NOTICE OF DECISION

MAP/TAX LOT: 2S131AB08200; 2S131AB08100;
2S131AB08000; 2S131BA08200
CASE NO: LU 2020-008 SP
DATE OF NOTICE: September 15, 2020

CITY OF SHERWOOD
September 15, 2020
Staff Report and Notice of Decision

SENESTRARO FAMILY ORTHODONTICS
SITE PLAN REVIEW
LU 2020-008

AKS DRAWING FILE: 6946 EXCOND.DWG | LAYOUT: P-03

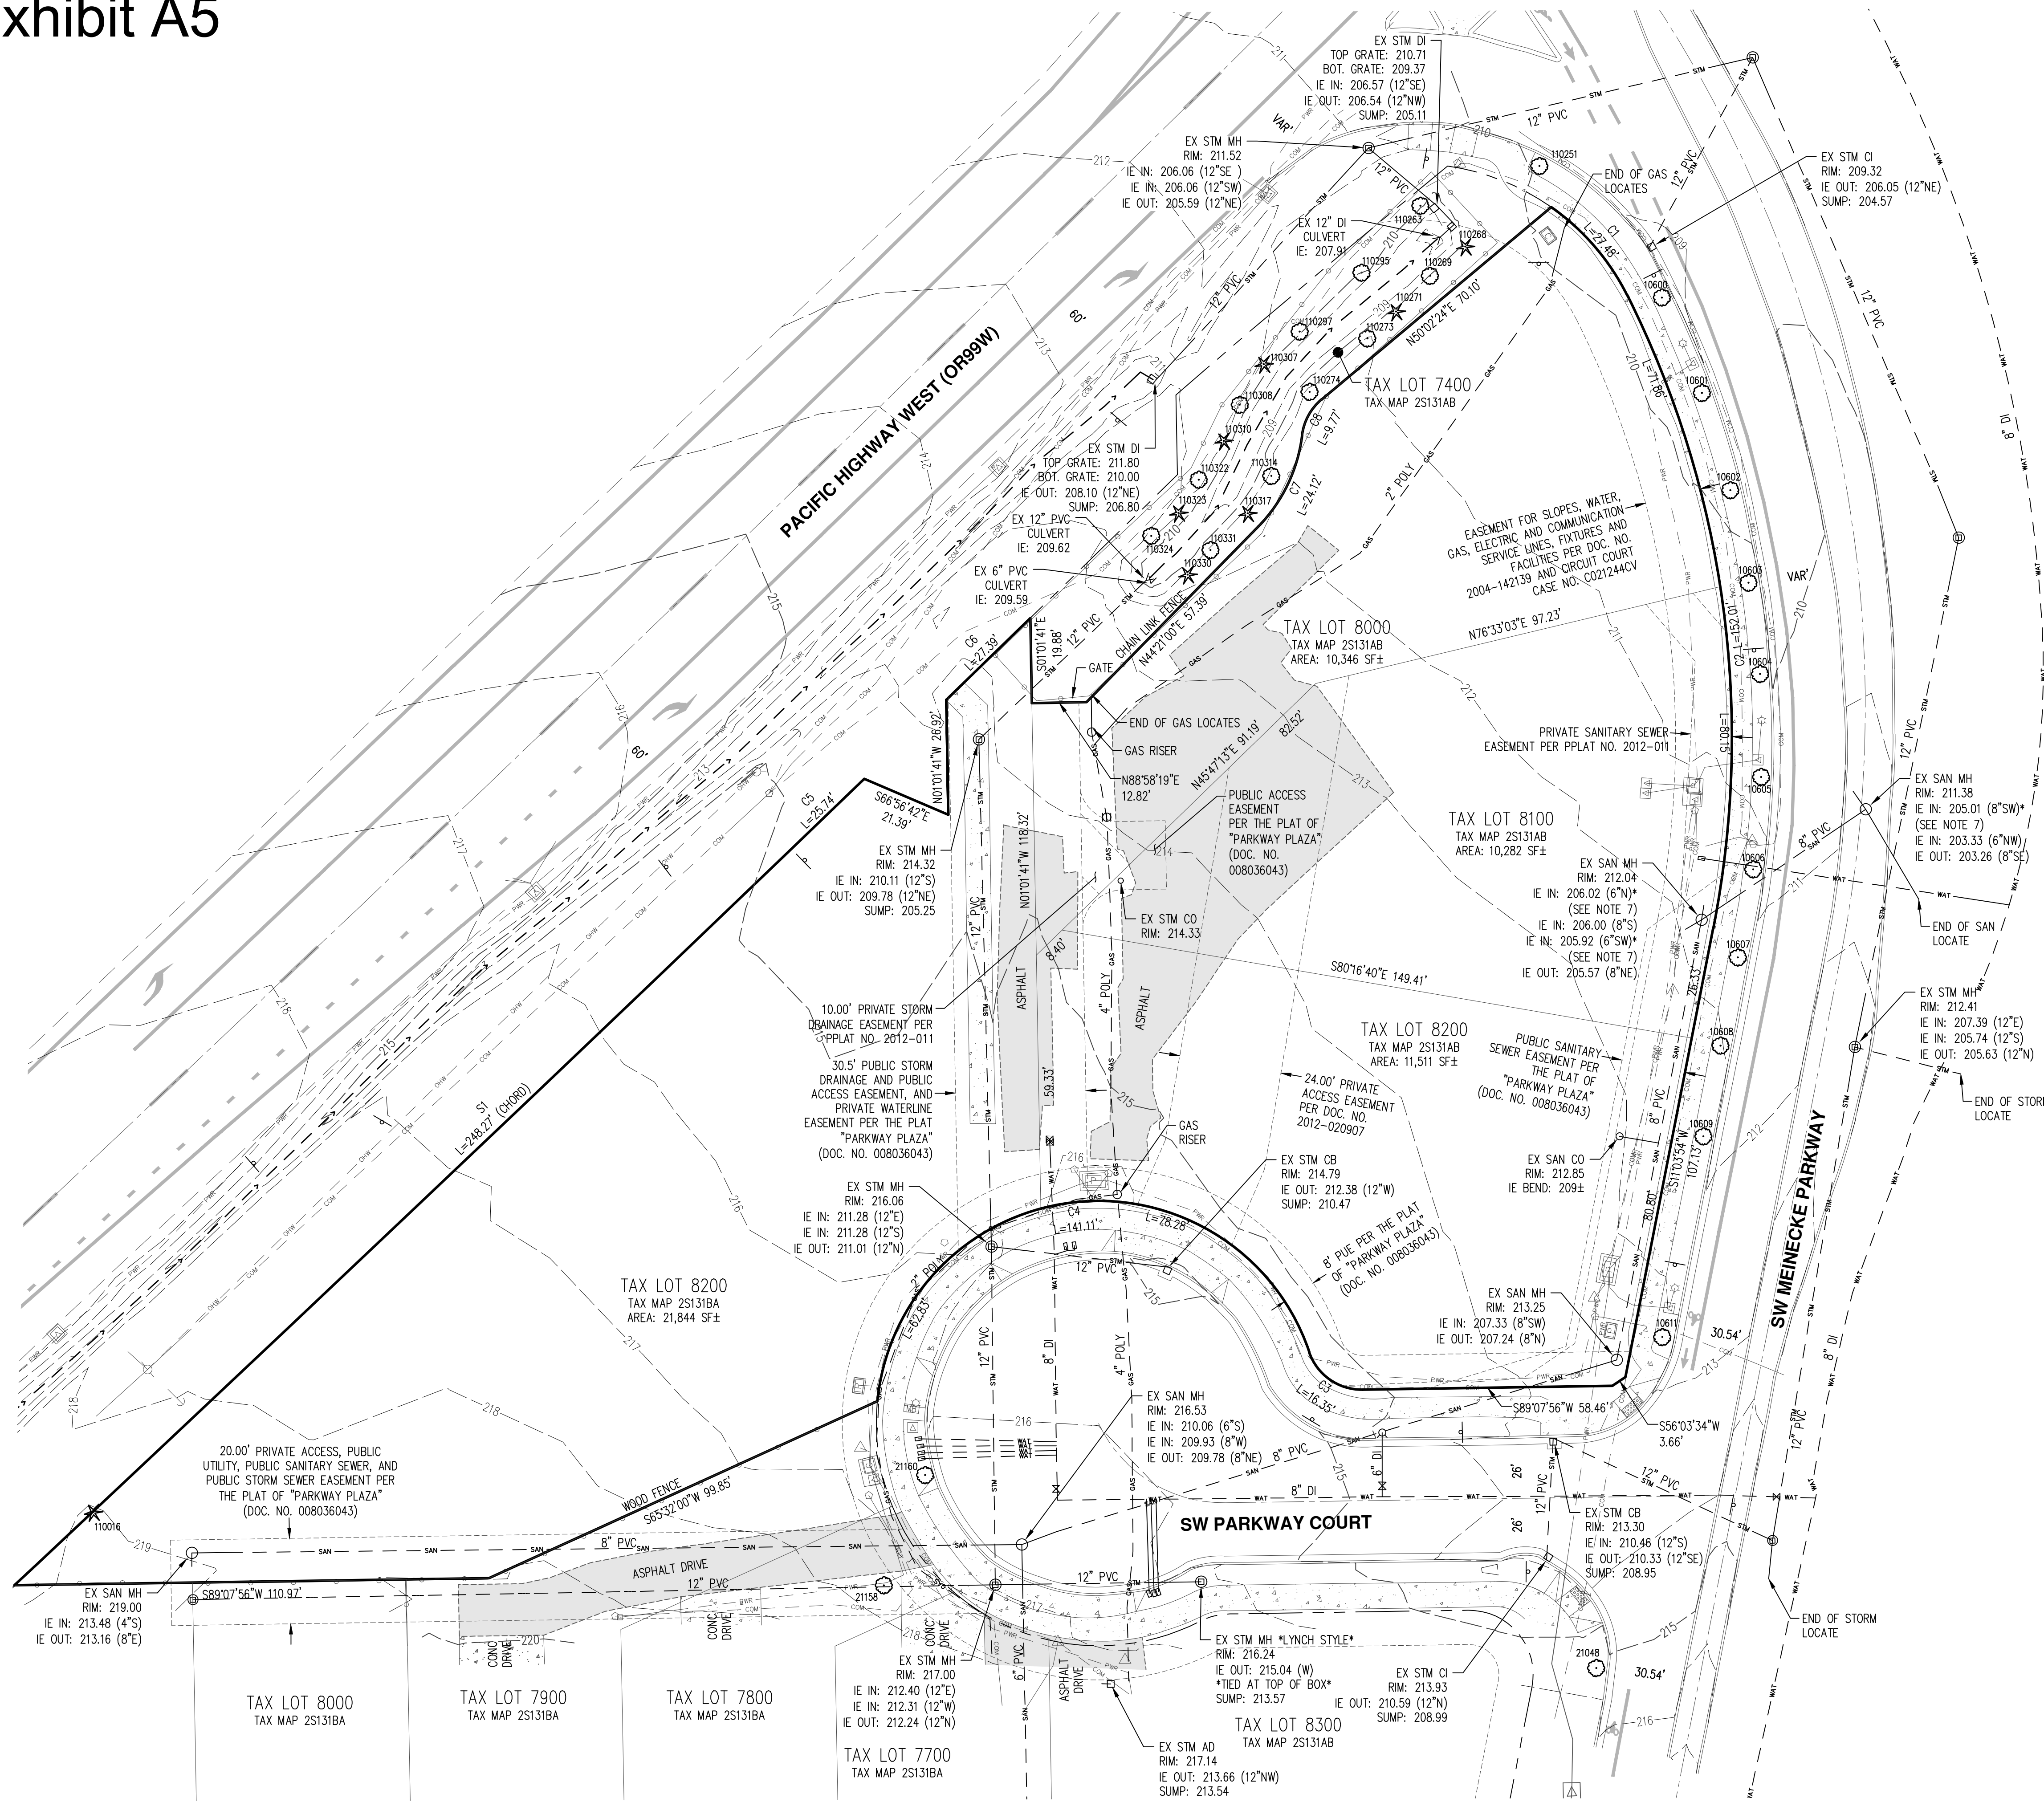
The site contains existing public and private underground utilities including sanitary sewer, storm drainage, and gas lines. Existing utilities and easement are shown on the Existing Conditions Plan included as Exhibit A5 – Sheet P-03. Some of the easements shown on the Existing Conditions Plan were provided in order to serve the previous development proposal and are no longer required. The applicant is proposing to extinguish the unnecessary easements and create new access and utility easements required in order to serve the development under single ownership. Details are provided in the Site Plan, Demolition Plan, and Composite Utility Plan within Exhibits A2 and A5.

ANALYSIS: The Existing Conditions Plan (Exhibit A5 – Sheet P-03) shows the location of public and private utilities on the site. In addition, the City of Sherwood Engineering Comments state that a PUE exists along SW Parkway Court and SW Meinecke Parkway along the subject property frontage. There is currently no PUE along the subject property frontage of SW Pacific Highway.

AKS DRAWING FILE: 6946 DEMO.DWG | LAYOUT: P-04

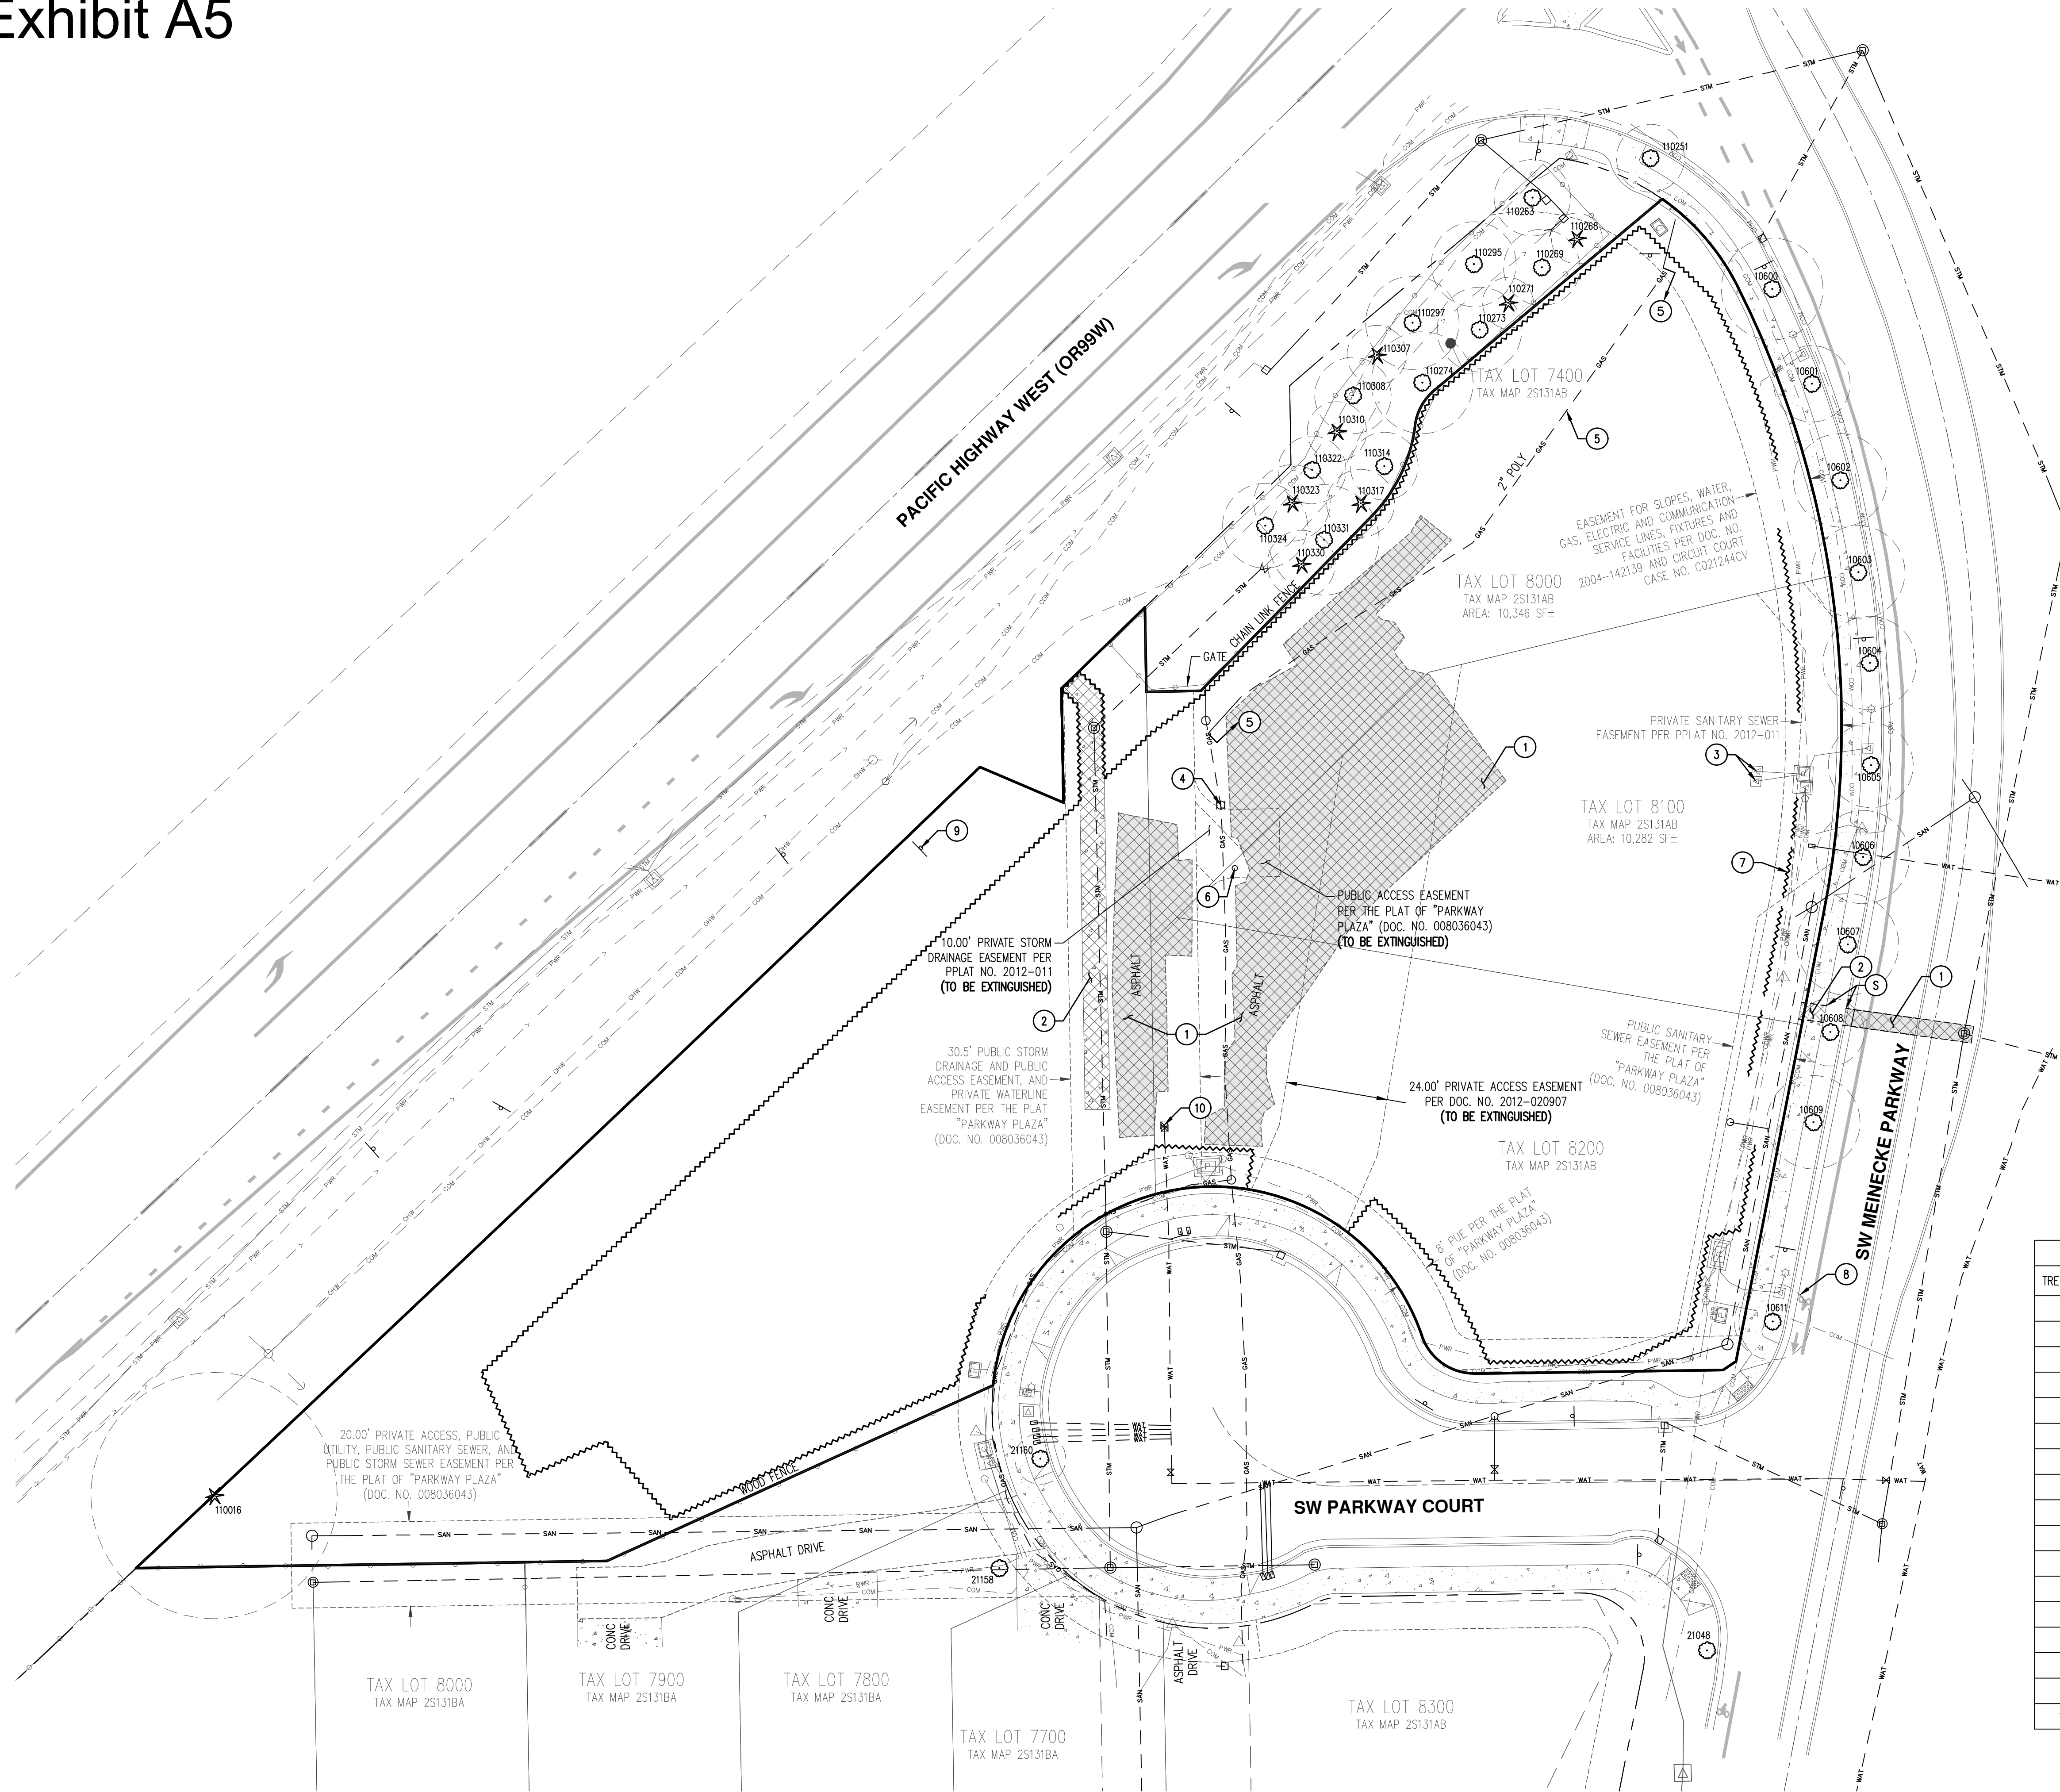
CONDITION OF APPROVAL G1: Prior to Receiving Occupancy, remove unnecessary private access and utility easements from property as shown in the Preliminary Tree Preservation and Demolition Plan (Exhibit A5 – Sheet P-04).

1. Prior to Receiving Occupancy, remove unnecessary private access and utility easements from property as shown in the Preliminary Tree Preservation and Demolition Plan (Exhibit A5 – Sheet P-04).
